The University of Mississippi Medical Center
2500 N State Street
Jackson, MS 39216

Project Name: UMMC Proj# 2606018 | Robbie Hughes Playground
Project Number: 23-057

ADDENDUM NO. 2

A101
ARCHITECTURAL
SITE PLAN

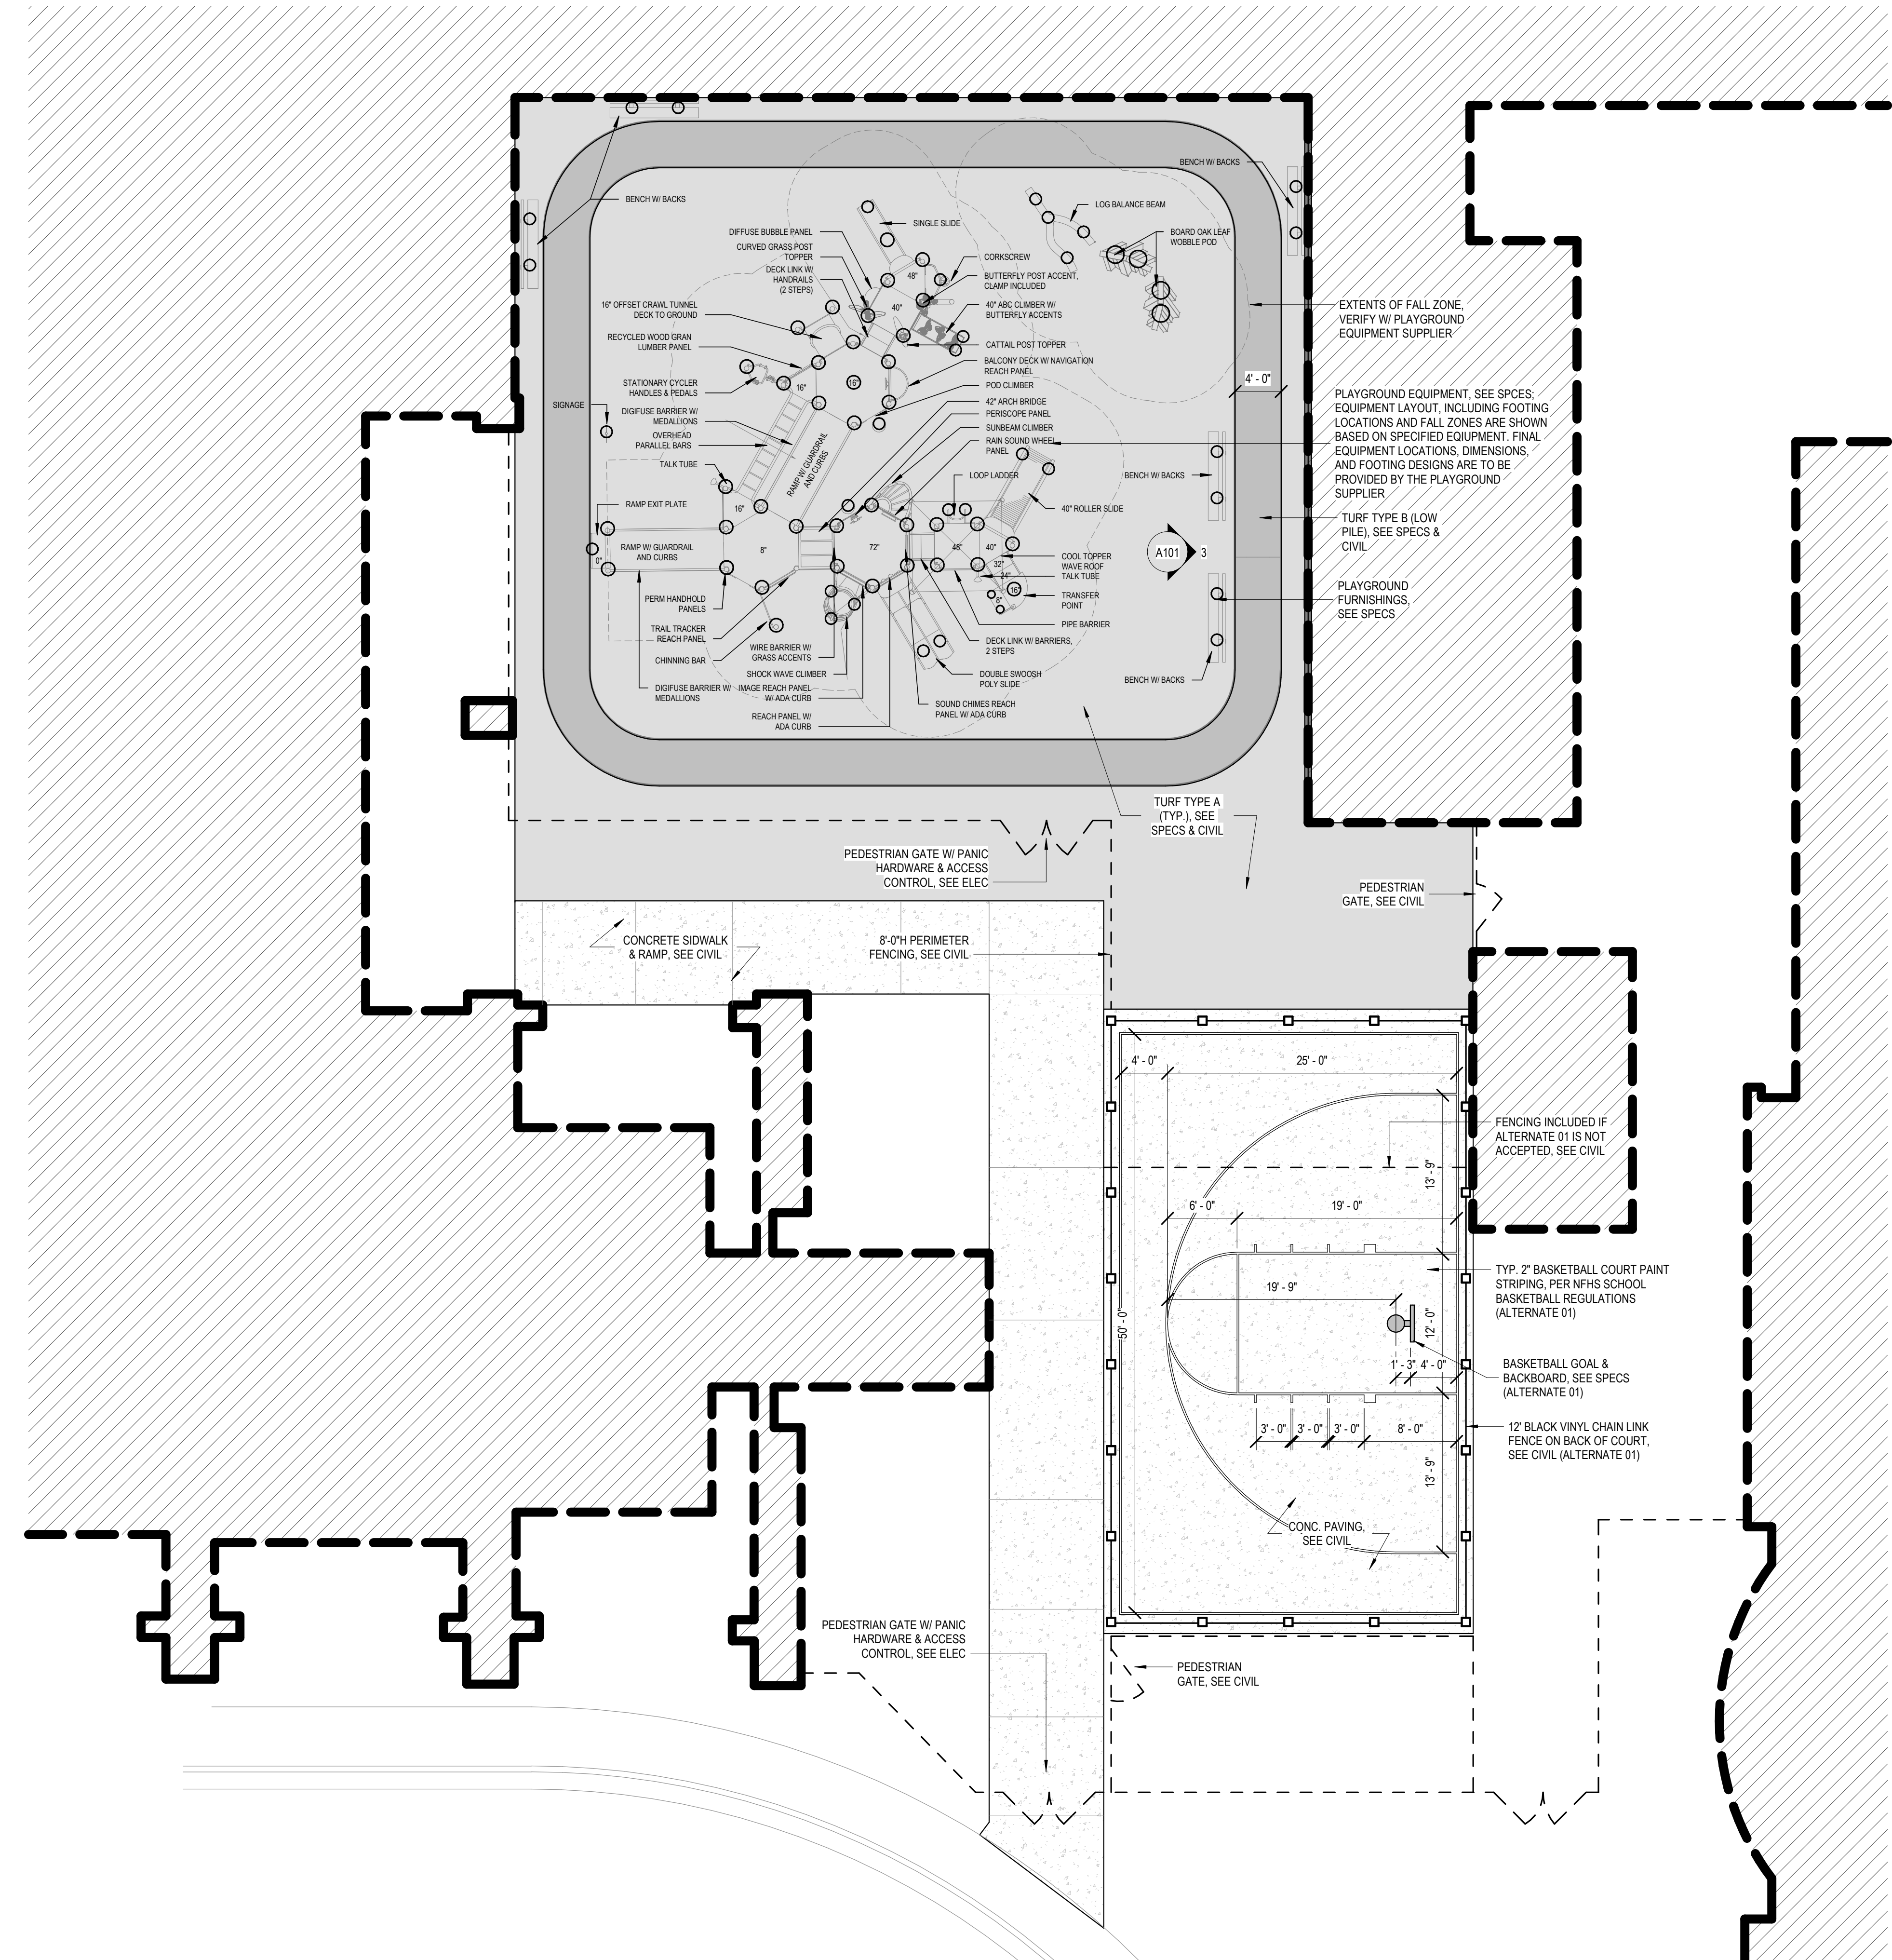
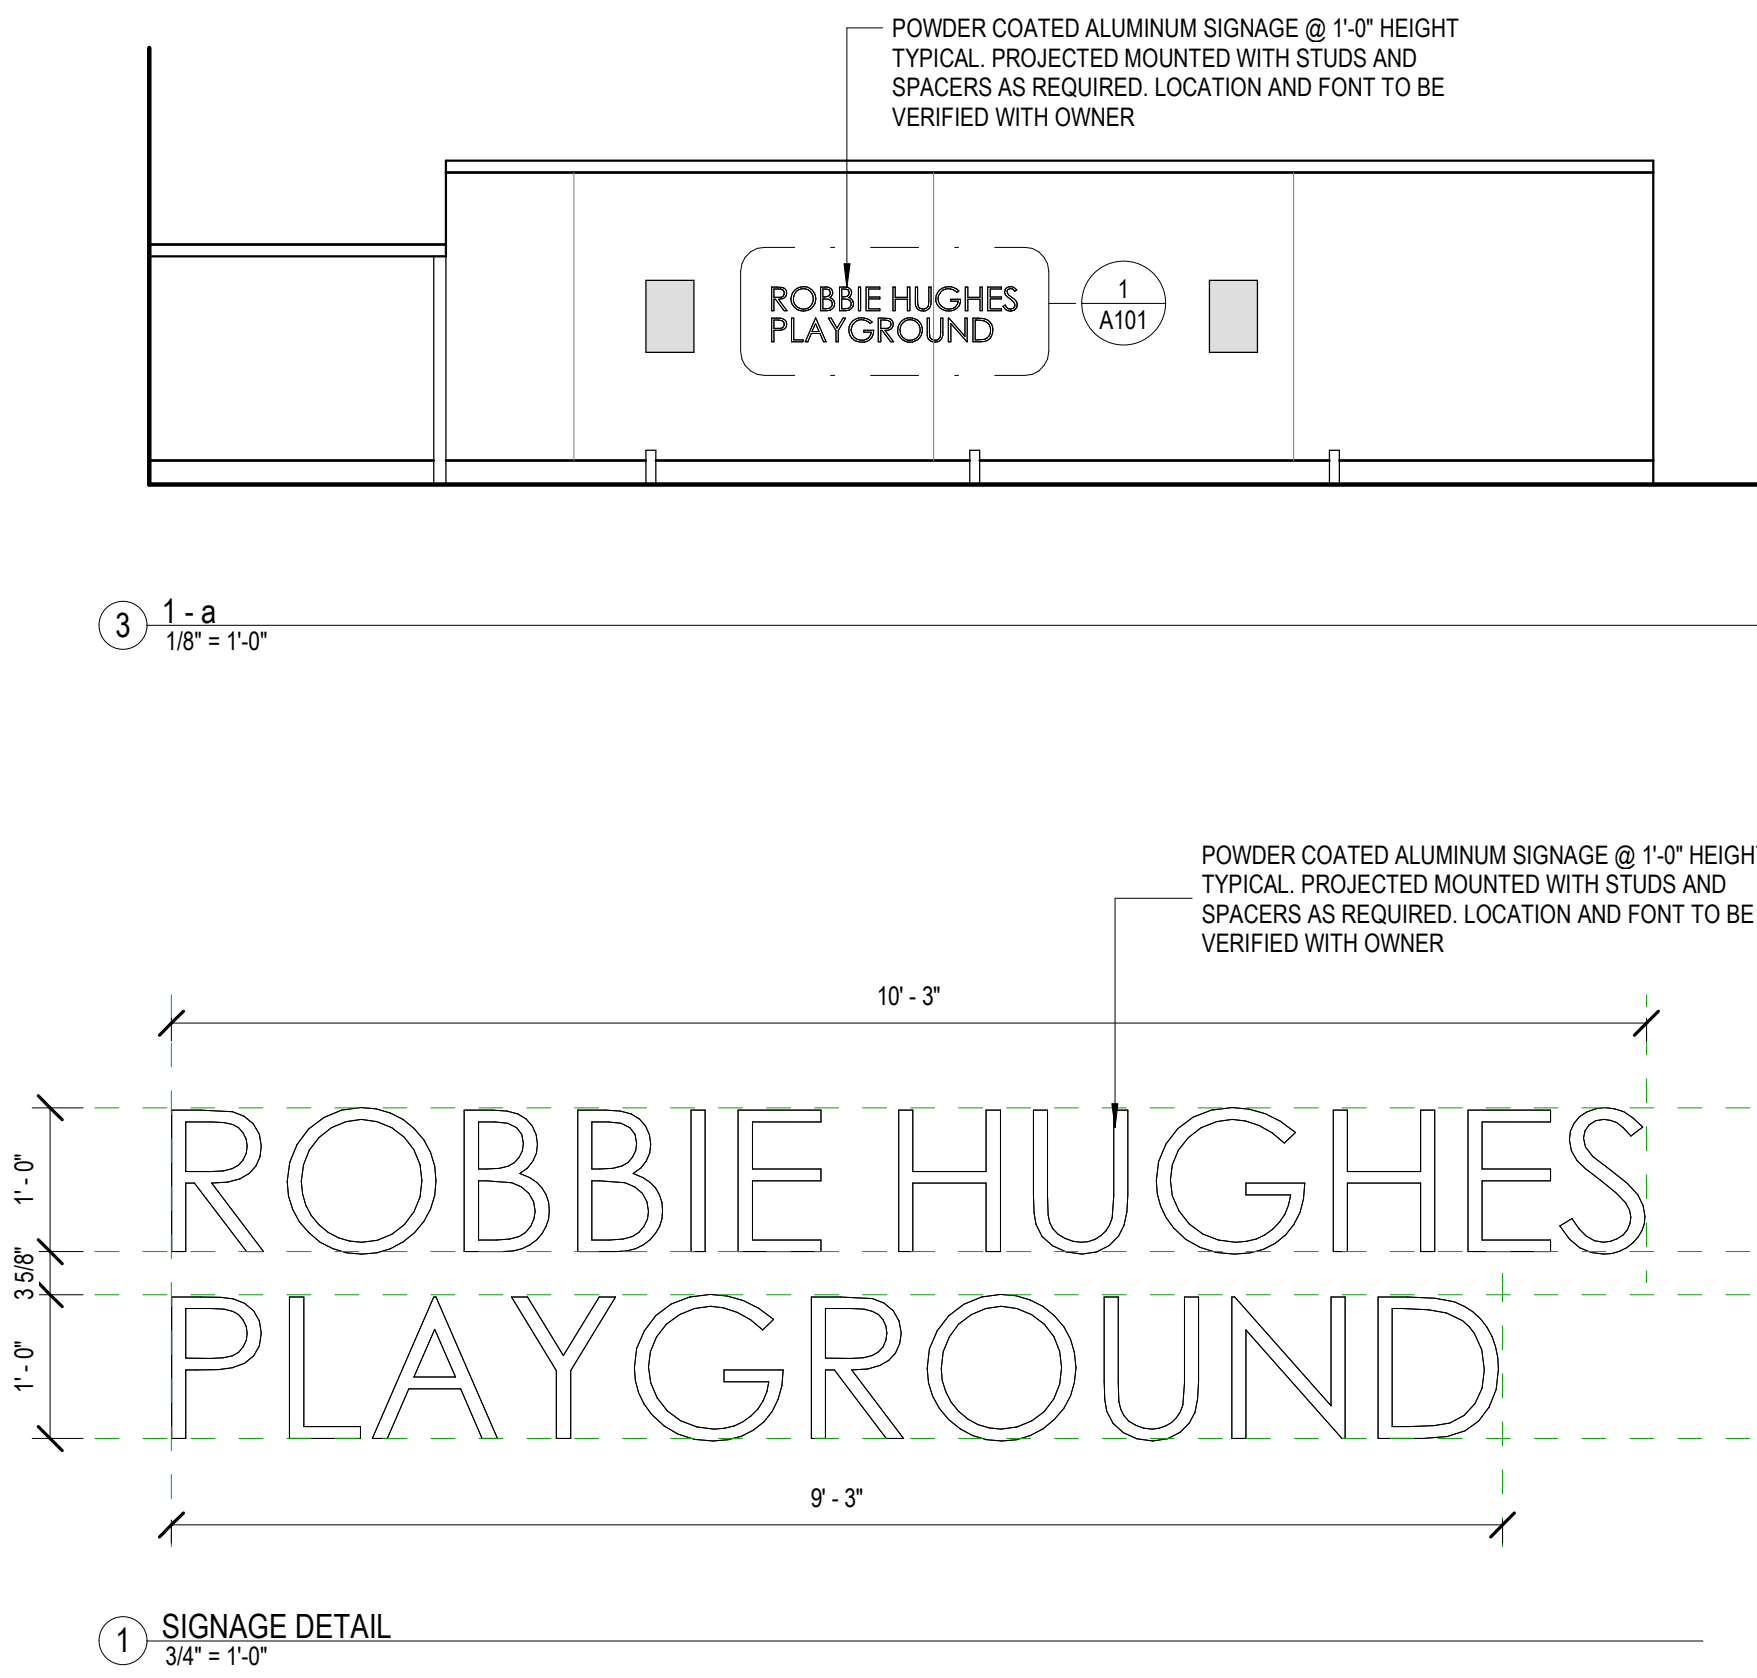
ITEM NO. 21 **A101 - ARCHITECTURAL SITE PLAN**

REPLACE the attached A101

CLARIFIES playground equipment and platform elevations.
